GENERAL INFORMATION ABOUT THE CONTENTS OF THIS FILE

SECONDARY SUBMISSIONS

Statement To Accompany Public Comment – October 24, 2019

TO: City Planning Commission

View from
Tennessee Avenue
(Facing Southeast)

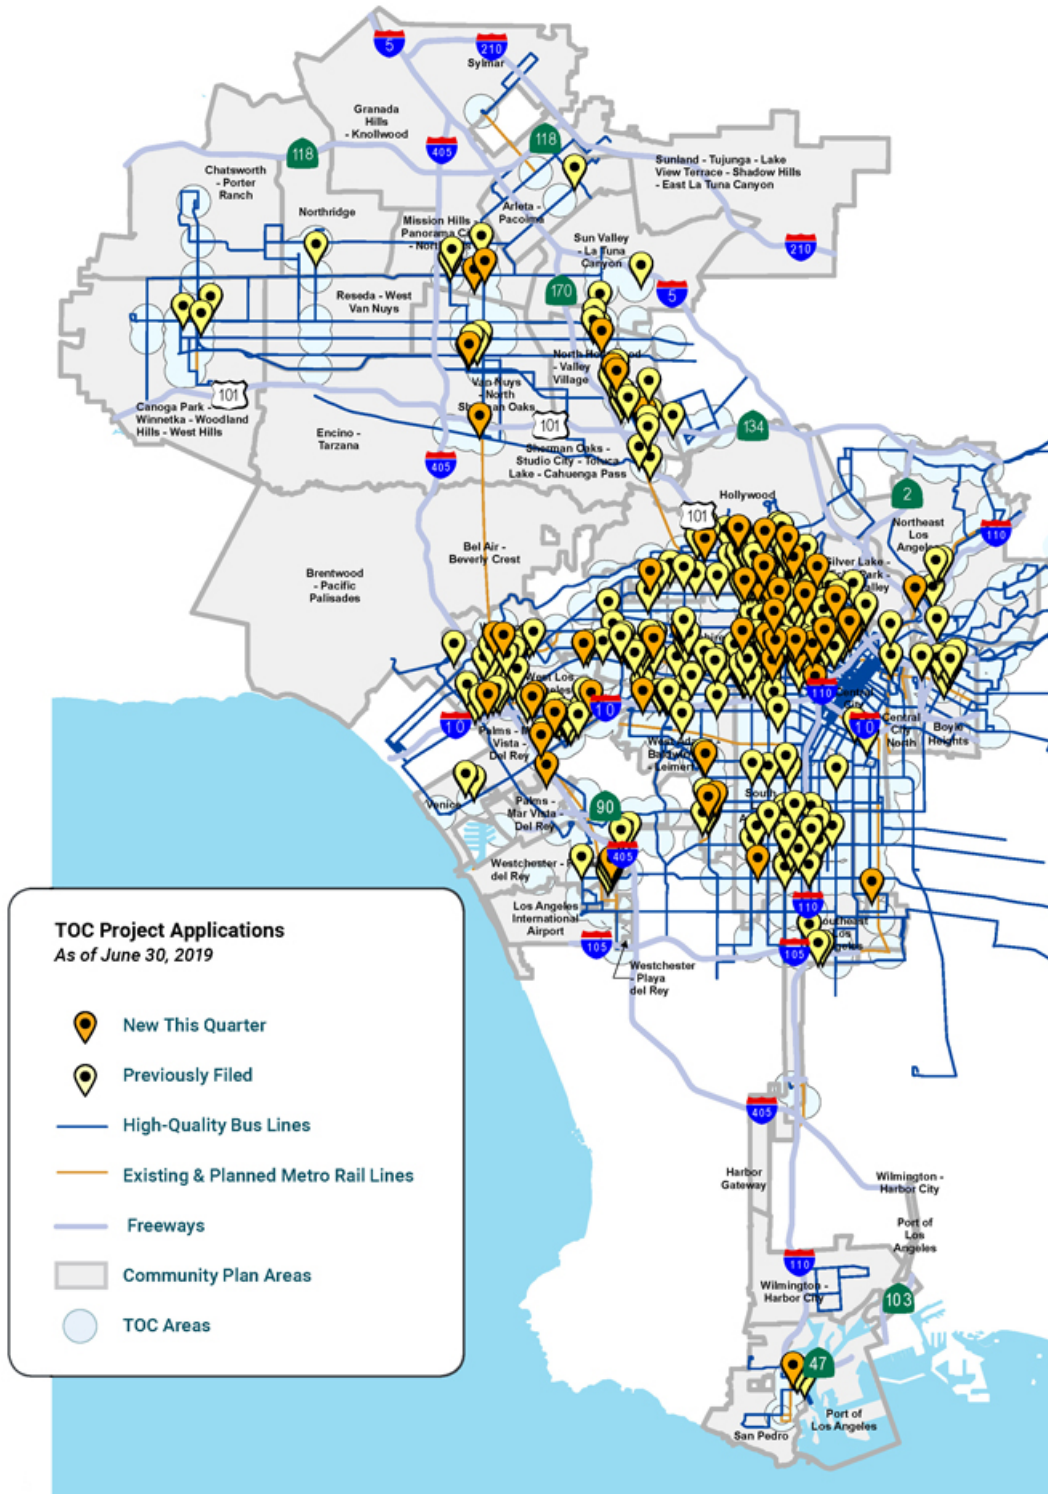
The City Planning Department's determination grants the project a Waiver of Street Dedication and Improvement of 3-feet on Tennessee Avenue. This waiver is in direct conflict with the designation of Tennessee Avenue as part of the City's Mobility 2035 Plan and, specifically, the street's important role as part of the Neighborhood and Bicycle Enhanced Network system. Tennessee is seen as a bicycle alternative to busy Pico Boulevard, one block to the south and Olympic Boulevard, one block to the north.

The ability to better separate motor vehicles from bicycles will provide for improved safety, for bicycle riders and drivers alike. A waiver of street dedication on Tennessee Avenue would make such separation much more difficult to achieve. The proposed parking structure entrance on Tennessee Avenue would create an additional safety hazard for cyclists.
